Model: M-G1a	Date: 25-May-09	No.: RJ017001j
--------------	-----------------	----------------

Subject: Firmware Release Note: Engine/Controller		Prepared by: Y. Gaman	
From: 1st Tech Service Sect., MFP/Printer Tech Service Dept.			
Classification:	<input type="checkbox"/> Troubleshooting <input type="checkbox"/> Mechanical <input type="checkbox"/> Paper path <input type="checkbox"/> Product Safety	<input type="checkbox"/> Part information <input type="checkbox"/> Electrical <input type="checkbox"/> Transmit/receive <input checked="" type="checkbox"/> Other ()	<input type="checkbox"/> Action required <input type="checkbox"/> Service manual revision <input type="checkbox"/> Retrofit information <input checked="" type="checkbox"/> Tier 2

Subject: Firmware Release Note: Engine/Controller		Prepared by: Y. Murata	
From: 3rd Tech Service Sect., MFP/Printer Tech Service Dept.			
Classification:	<input type="checkbox"/> Troubleshooting	<input type="checkbox"/> Part information	<input type="checkbox"/> Action required
	<input type="checkbox"/> Mechanical	<input type="checkbox"/> Electrical	<input type="checkbox"/> Service manual revision
	<input type="checkbox"/> Paper path	<input type="ch

Case example (when power was turned off by any other way than the power button)

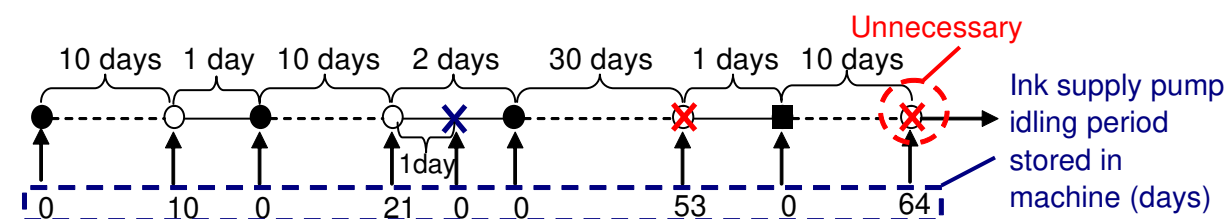
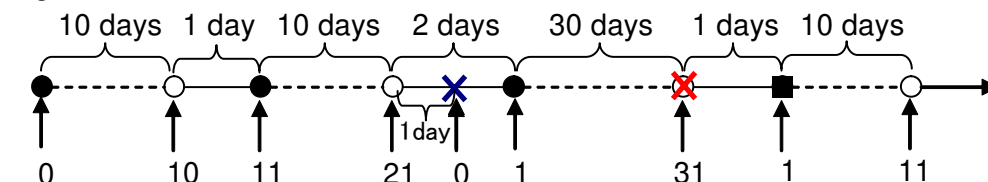
Changed the calculation formula of the power off period as follows.

Old: [Power ON date - Power OFF date (stored at power off)]

New: [Power ON date - Date of last time the ink supply pump was rotated (stored in a timely manner)]

Information about replacing the controller board

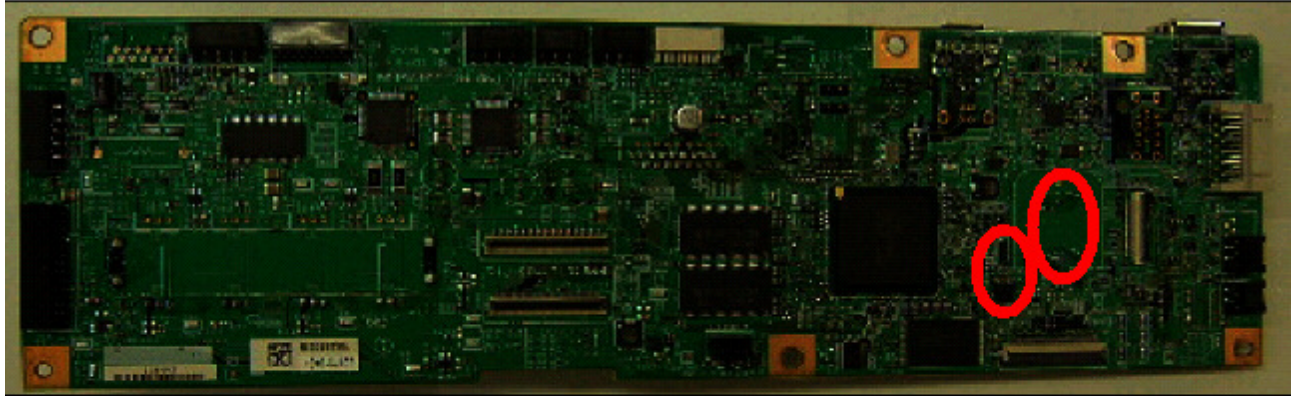
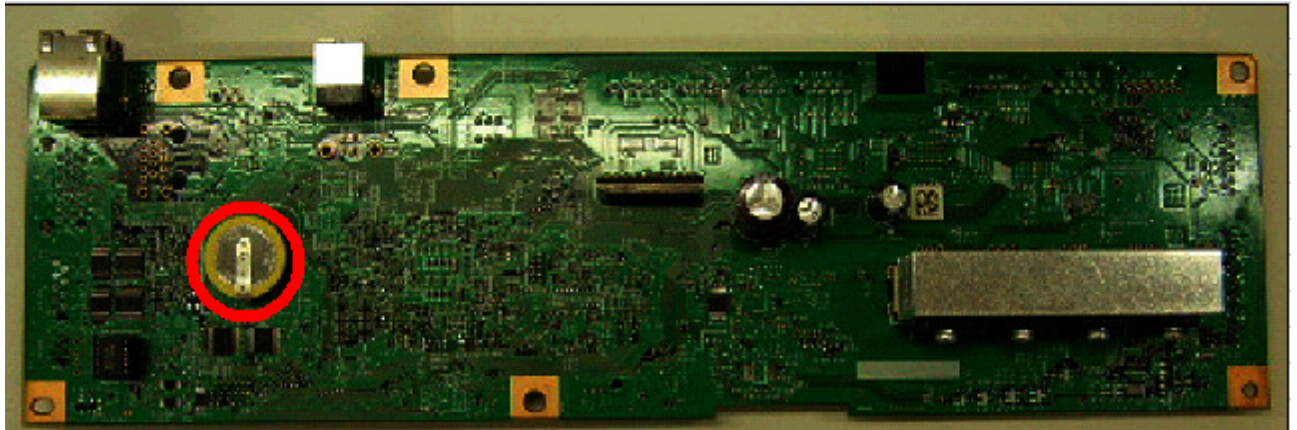
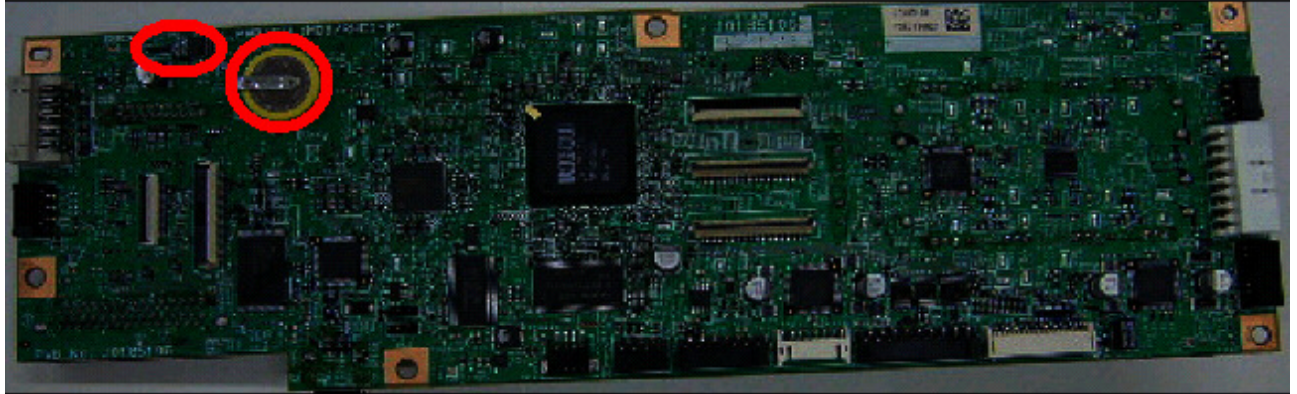
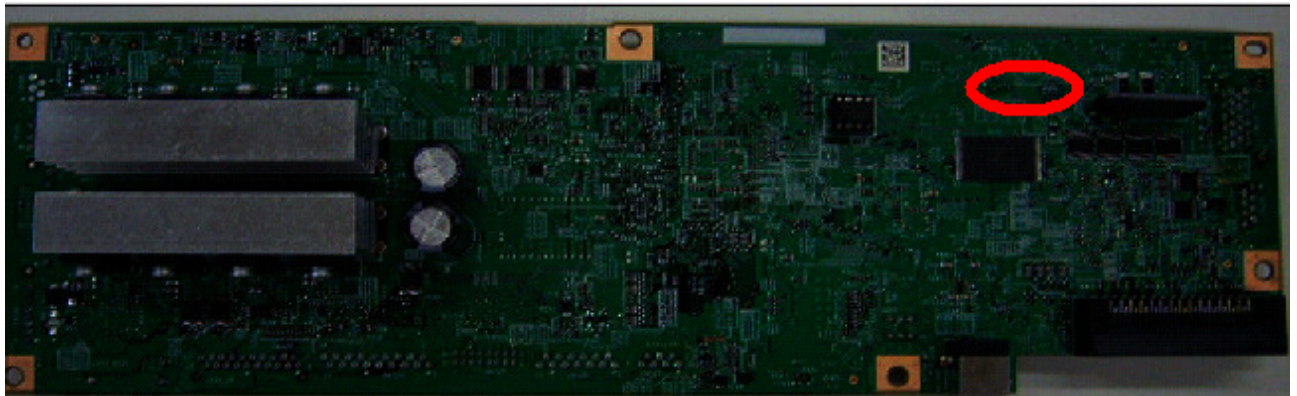
- When you replace the controller board, **DO NOT touch the areas circled in red below directly or with anything metallic.** If you do, **SC974** (RTC* malfunction) may occur.
 * **RTC: Real Time Clock**
- ***If SC974 occurs, turn the main power OFF/ON. If this does not clear the error, replace the controller board.***

BRACKET: PCB: CONTROL

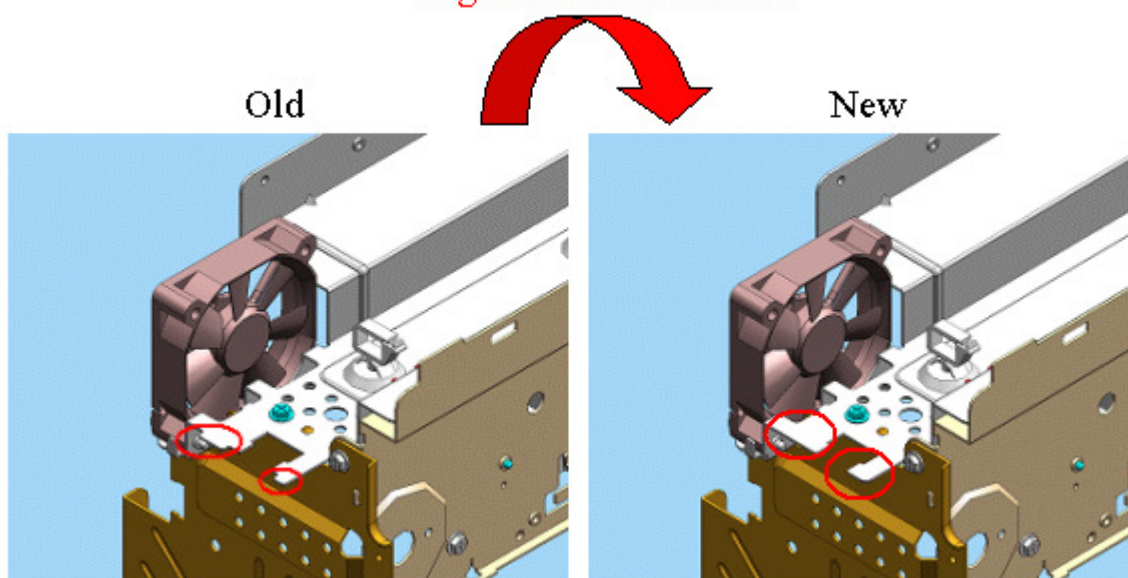
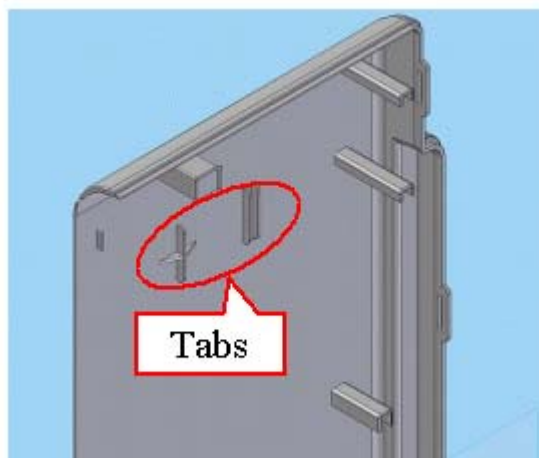
- 1) The shape of the left cover was changed.
- 2) The bracket for the PCB was added as a service part.

Note: The shape of the bracket was changed as shown in the illustration.

The small tabs on the tip of the bracket were removed.

COVER: LEFT: MOS-P1: EU
 Tabs were added.

Reason: To provide further protection against shock and vibration during product shipping.

Important: If you need to replace the cover on a machine produced before the cut-in serial numbers (see below), install the new cover and PCB **together as a set**.

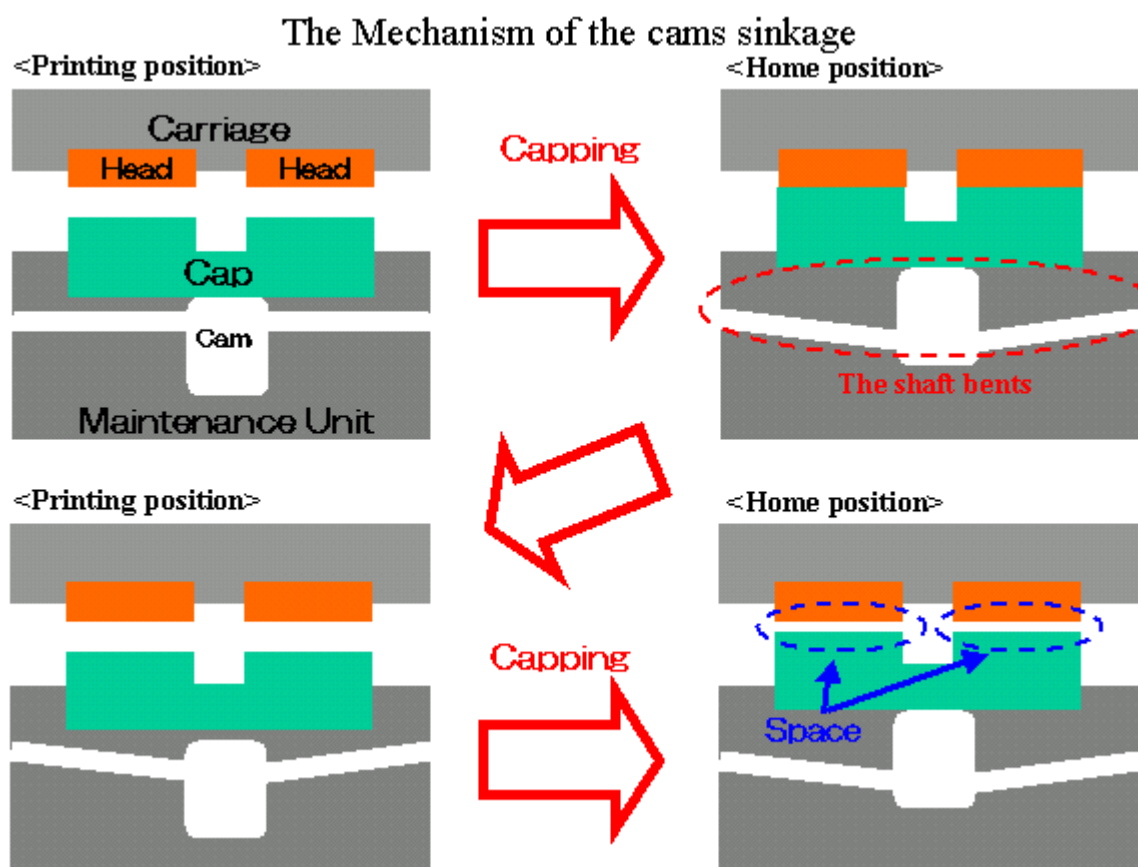
The carriage position lever is mistakenly set to the envelope position (rear position), which raises the carriage unit. A gap develops between the print heads and caps on the maintenance unit. As a result, the machine cannot properly perform ink suction (which causes the SC) or head cleaning (which causes the white lines).

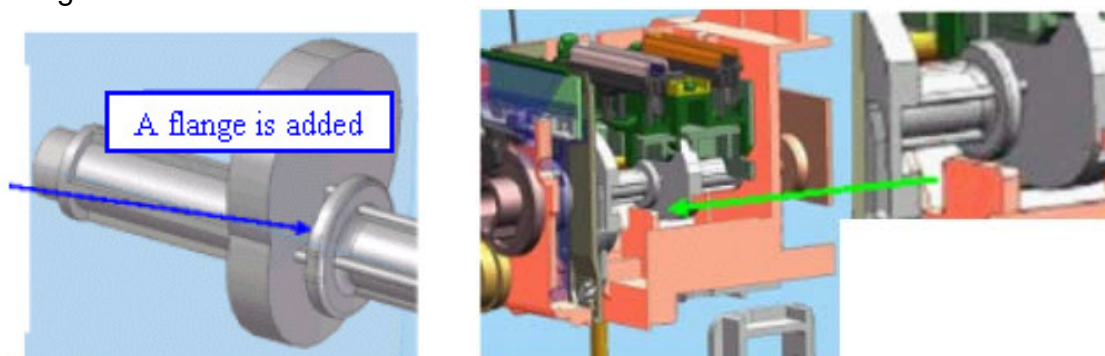
A flange was added to the cam on the maintenance unit.

Old Part #	New Part #	Description	Int.	Q'ty
J0170412	J0170413	MAINTENANCE RECOVERY (for J017/J019)	X/O	1

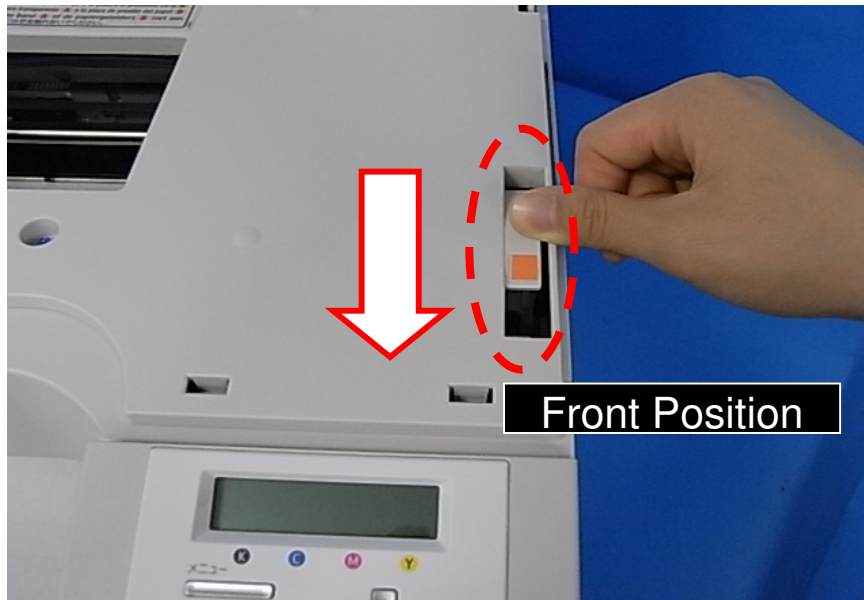
1. Please remind users not to move the carriage position lever to the envelope position when performing ink initialization. Also, remind them that the lever should be set to the front position except when printing onto envelopes.

2. For users that print onto envelopes only, replace the maintenance unit.

1. Cassette tray:

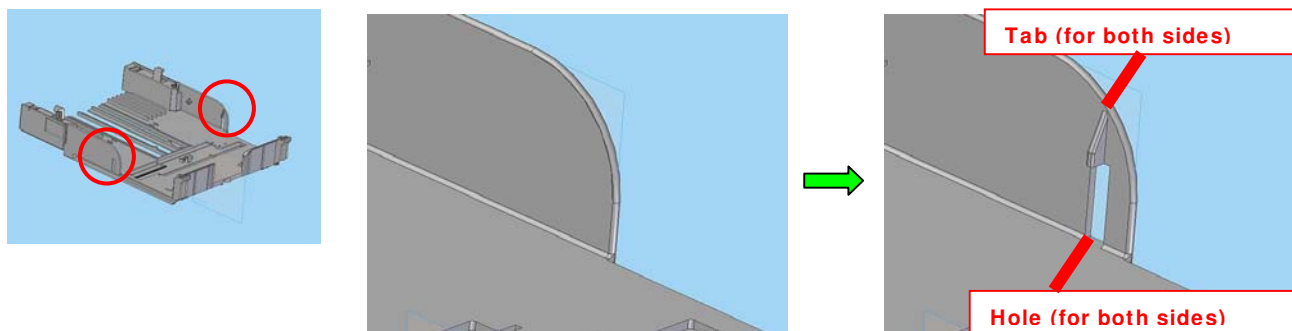
Tabs and holes were added to the left and right sides of the tray. This is to prevent the base plate from hitting the left arm.

Old Part #	New Part #	Description	Int.	Q'ty	Note
J0173034	J0170034	CASSETTE TRAY	X/O	1

2. Left side fence:

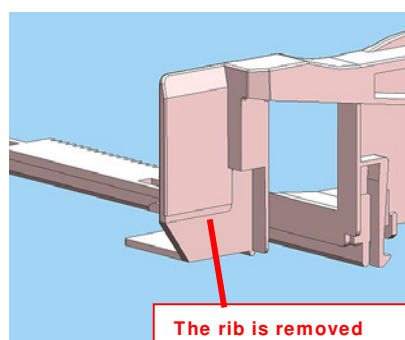
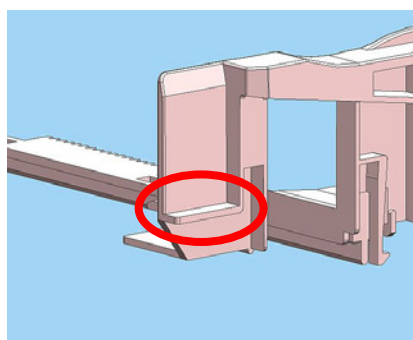
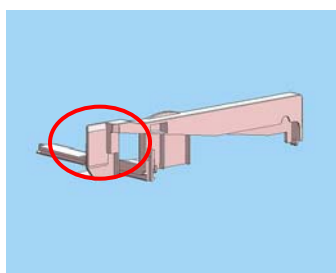
The rib was removed so that the left arm will not hit the trailing edge sensor even if the tray is set with the left arm incorrectly attached.

Old Part #	New Part #	Description	Int.	Q'ty	Note
J0173004	J0173007	SIDE FENCE: LEFT: A4	X/O	1

- Belt cleaning:

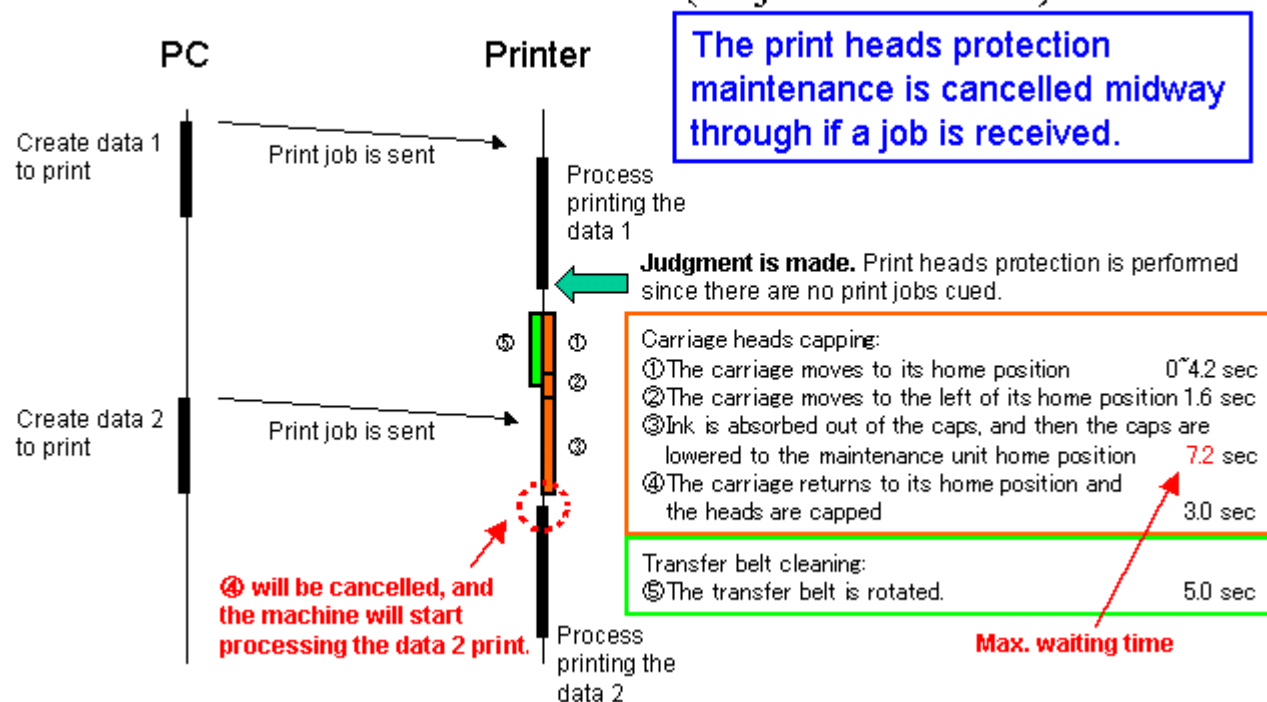
1. The cleaning interval was changed from every print job to every 250 pages.
2. Belt cleaning and carriage head capping are performed at the same time.

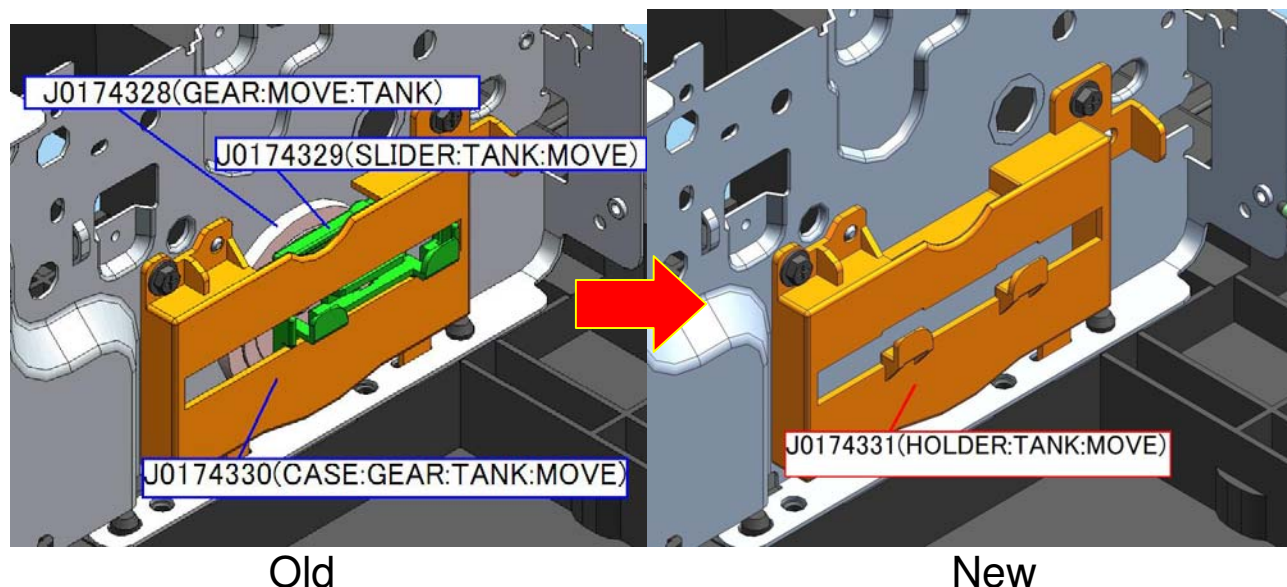
- 1) The gear and slider were deleted.
- 2) The shape of the case was changed.

Reason: Optimization of service parts (the slider is no longer needed to ensure the case/holder reaches its yield).

Important: When you install the new holder (J0174331) for the first time, make sure to remove the gear (J0174328) and the slider (J0174329).
